## 7.2 Reactor Protection (Trip) System (RPS)—Instrumentation and Controls

The information in this section of the reference ABWR DCD, including all subsections, tables and figures, is incorporated by reference with the following departures and supplements.

STD DEP T1 2.3-1 (Table 7.2-1, 7.2-2, Figures 7.2-2, 7.2-6, 7.2-9, 7.2-10)

STD DEP T1 3.4-1 (Figures 7.2-2, 7.2-9, 7.2-10)

Figure 7.2-2 Reactor Protection System Equipment Arrangement (From Sensors Through Trip Actuators)

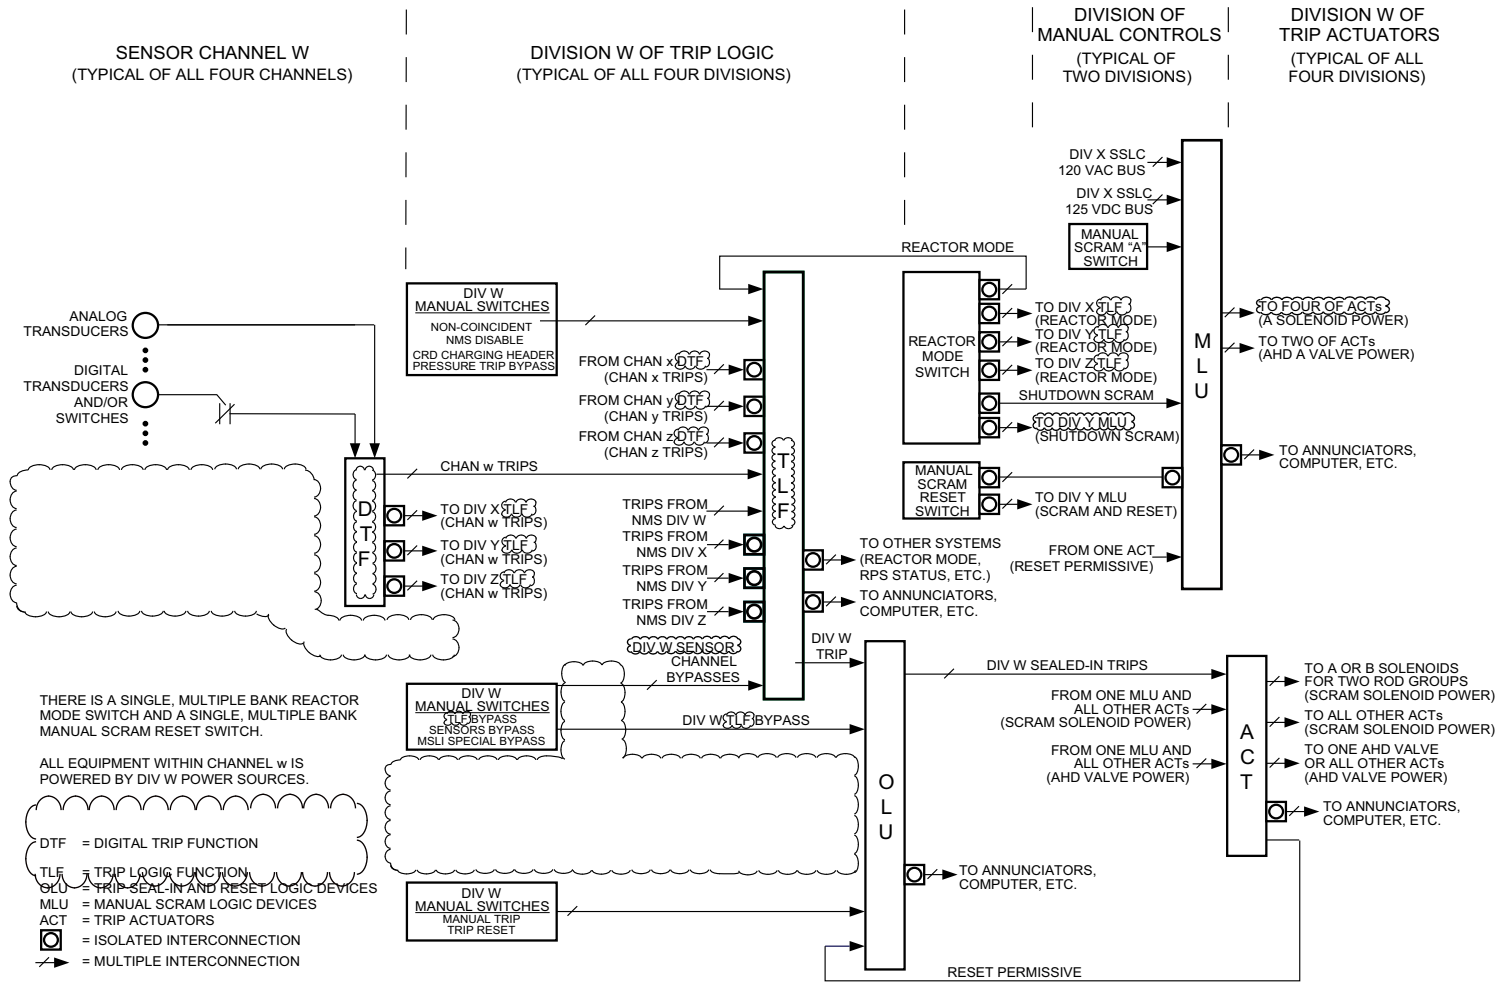
The RPS equipment is divided into four redundant divisions of sensor (instrument) channels, trip logics and trip actuators, and two divisions of manual scram controls and scram logic circuitry. The sensor channels, divisions of trip logics, divisions of trip actuators and associated portions of the divisions of scram logic circuitry together constitute the RPS scram and air header dump (backup scram) automatic initiation logic. The divisions of manual scram controls and associated portions of the divisions of scram logic circuitry together constitute the RPS scram and air header dump manual initiation logic. The automatic and manual scram initiation logics are independent of each other. RPS equipment arrangement is shown in Figure 7.2-2.

Four independent sensor channels monitor the various process variables listed in Subsection 7.2.1.1.4.2. The redundant sensor devices are separated so that no single failure can prevent a scram. The arrangement of RPS sensors mounted in local racks is shown in Figure 7.2-2. Locations for local RPS racks and panels are shown on the instrument location drawings provided in Section 1.7. ~~Divisional separation is also applied to the Essential Multiplexing System (EMS) D which provides data highways for the sensor input to the logic units. Physically separated cabinets are provided for the four scram logics. Fiber optic cable routing from remote multiplexing units (RMUs) remote digital logic controllers to control room equipment is shown in raceway plans provided by reference in Section 1.7.~~ The criteria for separation of sensing lines and sensors are discussed in Section 7.1.

Figure 7.2-6 Division 1 Trip Logic

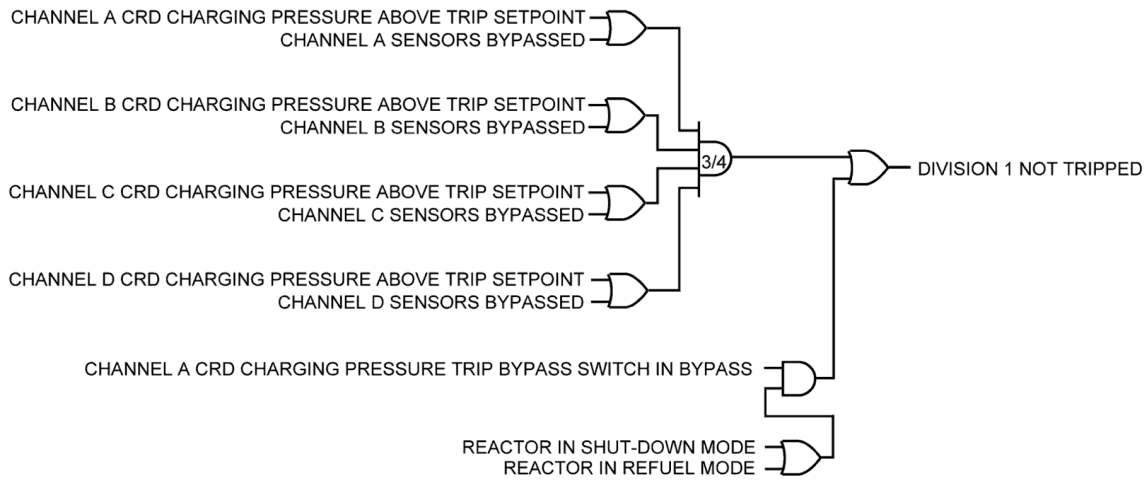
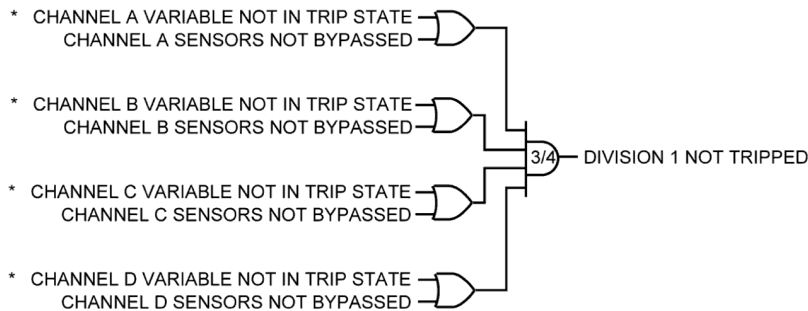
(2) Nuclear Boiler System (NBS) (Figure 7.2-6)

(3) Control Rod Drive (CRD) System (Figure 7.2-6)

LOW CRD CHARGING HEADER PRESSURE  
(TYPICAL OF ALL FOUR DIVISIONS)

- \* TYPICAL OF – REACTOR PRESSURE ABOVE TRIP SETPOINT
- REACTOR WATER LEVEL BELOW TRIP SETPOINT
- DRYWELL PRESSURE ABOVE TRIP SETPOINT
- SUPPRESSION POOL TEMPERATURE HIGH

(TYPICAL OF ALL FOUR DIVISIONS)
